Project	IEEE 802.16 Broadband Wireless Access Working Group < http://ieee802.org/16 >	
Title	Correction to Rx SNR, Rx sensitivity, and Tx Relative Constellation Error for OFDM and OFDMA systems.	
Date Submitted	2005-09-09	
Source(s)	Darcy Poulin [SiGe Semiconductor], Paul Pigginn [Cygnus Multimedia Communications], Ran Yaniv [Alvarion], Dov Andelman [Intel]	Voice: [613-820-9244 x274] Fax: [Fax Number] [dp@sige.com] , ppigginn@cygnuscom.com
Re:	IEEE P80216_Cor1_D4	
Abstract	Correction to Rx SNR, Rx sensitivity, and Relative Constellation Error for OFDM and OFDMA systems.	
Purpose	The Rx SNR values in 802.16-2004 are incorrect. As a result, relative constellation error (EVM) and Rx sensitivity are also in error. In addition, there are many inconsistencies throughout section 8.3, 8.4, and 12.4 specifying EVM and Rx SNR. This submission attempts to resolve these inconsistencies.	
Notice	This document has been prepared to assist IEEE 802.16. It is offered as a basis for discussion and is not binding on the contributing individual(s) or organization(s). The material in this document is subject to change in form and content after further study. The contributor(s) reserve(s) the right to a

BS EVM = SS SNR + 10 dB

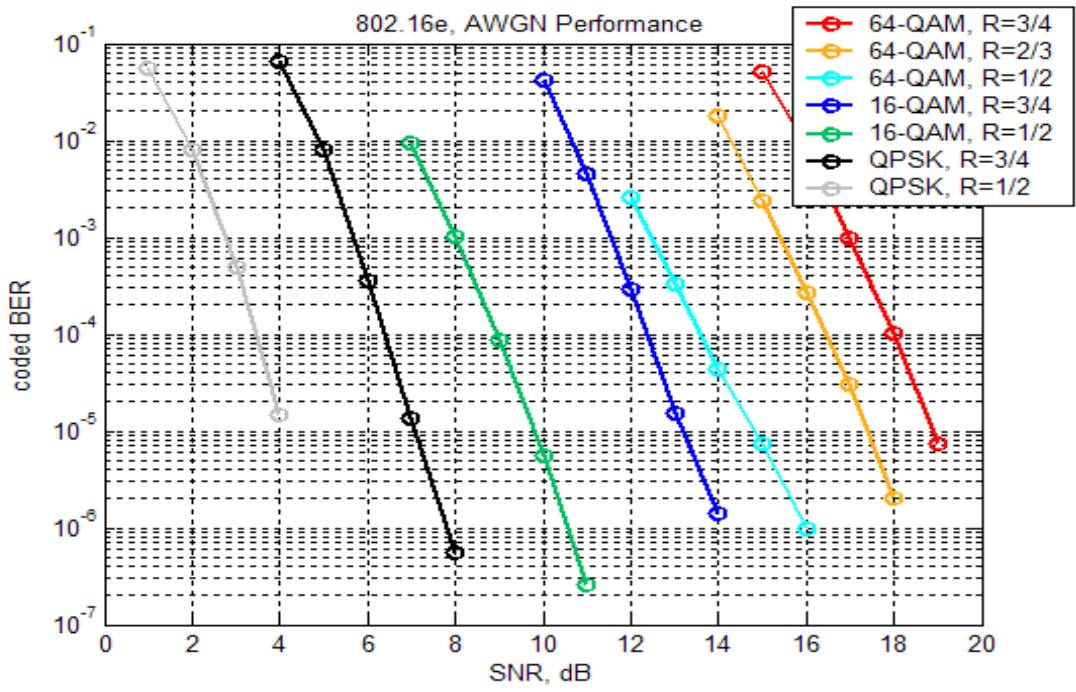
For base stations, we will not put a cap on EVM, so it remains at -31 dB. This will result in a worst case degradation of the SNR of 1.2 dB for 64QAM-3/4.
